Stop Use & Product Recall

3M™ PROTECTA® Cobra Rope Grab AC202D

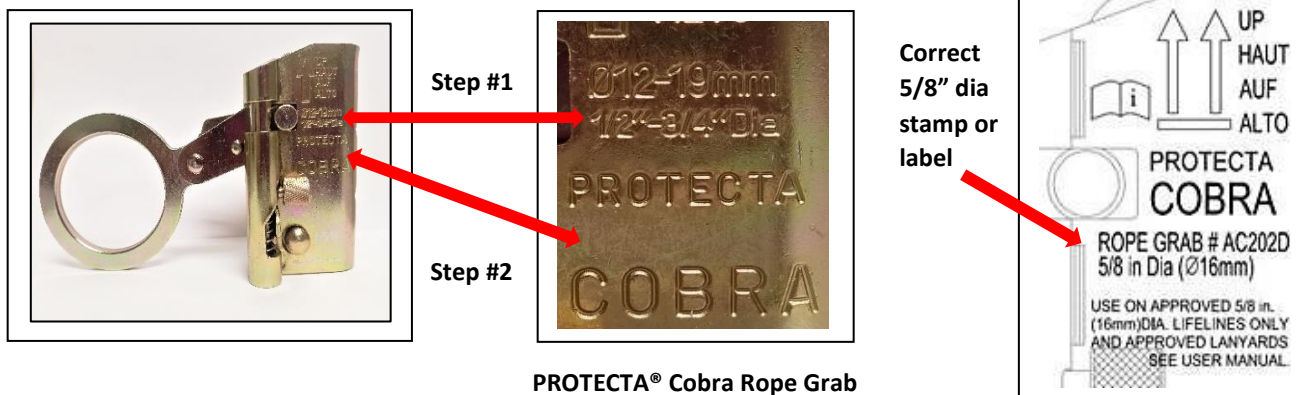
3M Fall Protection has determined that the 3M™ PROTECTA® Cobra Mobile/Manual Rope Grab AC202D is incorrectly stamped for use with 1/2 to 3/4 inch diameter rope on the exterior body of the unit. This Cobra Rope Grab is certified for use **ONLY** with 5/8 inch diameter polyester or polypropylene rope. All marketing information and the Instructions for Use (IFU) for this rope grab correctly identify the size of rope to be used as 5/8 inch polyester/polypropylene rope.

Step 1: Verify the rope diameter is stamped **1/2"—3/4" Dia** on the front side of the unit

Step 2: Verify the rope grab is stamped **PROTECTA COBRA** on the front side of the unit

If the information in Step 1 and Step 2 is stamped onto the side of the rope grab as illustrated above, remove the unit from service immediately. Owners of AC202D Cobra Rope Grabs can choose one of the following options for each affected rope grab they own:

Note: If the unit is stamped 5/8 inch diameter **OR** if the unit has a white label showing 5/8 inch diameter, then the unit is safe to return to normal use (see image on right for correct 5/8" diameter marking).

1. A free, new, properly marked replacement AC202D Cobra Rope Grab; or
2. A check for \$100.
